4th May 2026.**MINUTES FOR SITE MEETING HELD ON 4th MAY 2026 FOR GARDEN DEVELOPMENT, MABUSHI, ABUJA FCT.**

Location: Mabushi
Project: Event Center at Plot 2030 Mabushi
Facilitator: Arc. Chike

Fig. 1 Culvert with debris in water path

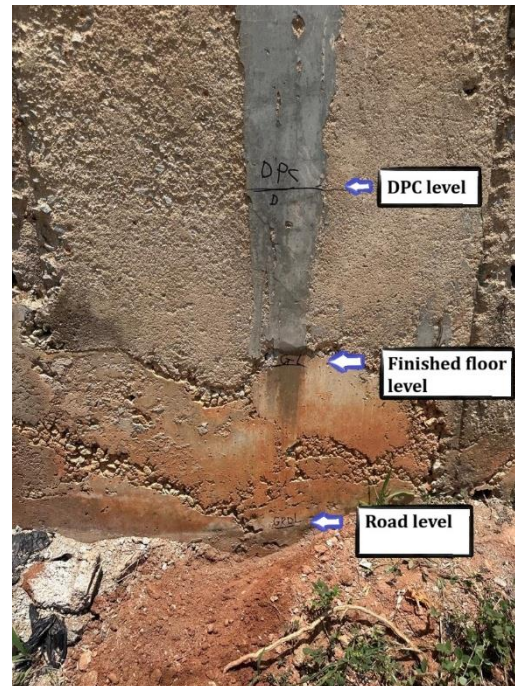
ITEM	DESCRIPTION	ACTION
1	<u>Drainage:</u> The surveyor requested a plan for the drainage, particularly for the culvert, as the existing rings are undersized (see Fig. 1). Engr. Kanabe stated that he has been informed that the contract for the access road has been awarded. His intention is to wait for the road contractor to mobilize to site, as the cost of constructing a box culvert is significant. The surveyor advised that the size of the culvert rings should be increased as soon as possible to prevent future drainage issues. Arc. Chike recommended that work should commence on site, particularly in establishing levels. This will help reduce debris and litter currently obstruct the drainage path, allowing water to flow more freely. He added that by the time this is achieved, the road contractor may have mobilized, after which the replacement of the culvert rings can be properly considered.	Consultant Engineer

All debris and litter within the existing drainage channel should be cleared immediately to restore free flow of water.

Following this, the drainage system should be observed under normal flow conditions to assess its performance. The decision to upgrade or redesign the culvert should be based on this assessment, alongside considerations of the proposed finished floor levels.
